Access Compliance Report

Public Rights-of-Way (Curb Ramps)

Intersection ID: 10020374	Main Street: BALLANTYNE CORPORATE PL	Cross Street: N/A	Location: SE
ADA ID: CE902285C29C	Ramp Type: Directional	Initial Pass/Fail: Fail	Overall Compliance: No
Codes/Mitigation Info/Possible Solution		Field Measurements/Component Compliance	
Severity Score: 21.25

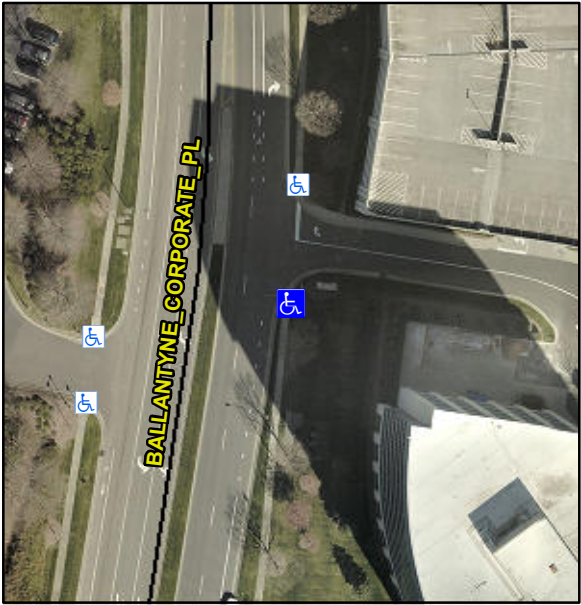
Possible Solutions:				
	Remove & Replace Entire Ramp.				
	Surveyor Notes:				
	N/A				
	PROW/ADA:				
	R304.5.1, R304.5.3				
	Street 1 Name	ENTRANCE			
	Stop Condition-Street 1	StopSign			
	Street 2 Name	N/A			
	Stop Condition-Street 2	N/A			
Total Cost:		\$ 1600.00			
			Compliance	Description	Data
			N/A	Ramp Length (in)	52.0
			No	Ramp Width (in)	46.0
			Yes	Ramp Slope (%)	3.9
			No	Ramp XSlope (%)	5.3
			N/A	Flare Type LT	N/A
			N/A	Flare Slope LT (%)	N/A
			N/A	Flare Traversable LT?	N/A
			N/A	Landing Length (in)	0.0
			N/A	Landing Width (in)	0.0
			N/A	Landing Slope (%)	0.0
			N/A	Landing X Slope (%)	0.0
			N/A	Landing Curb? (Y/N)	N/A
			N/A	Shared Landing?	N/A
			N/A	Gutter Ponding?	0.0
			N/A	Gutter Lip Ht (in)	0.0
			N/A	Painted X Walk1?	No
				X Walk 1 Direction	To NW
				X Walk 1 Width (in)	N/A
				X Walk 1 Slope (%)	1.7
				X Walk 1 X Slope (%)	7.6
			N/A	Ramp inside XWalk1?	N/A
			N/A	Any Obstructions?	N/A

Obstruction Type	
			Yes	Surface Condition? (G/P)	Good
			N/A	Curb Slope (%)	7.0
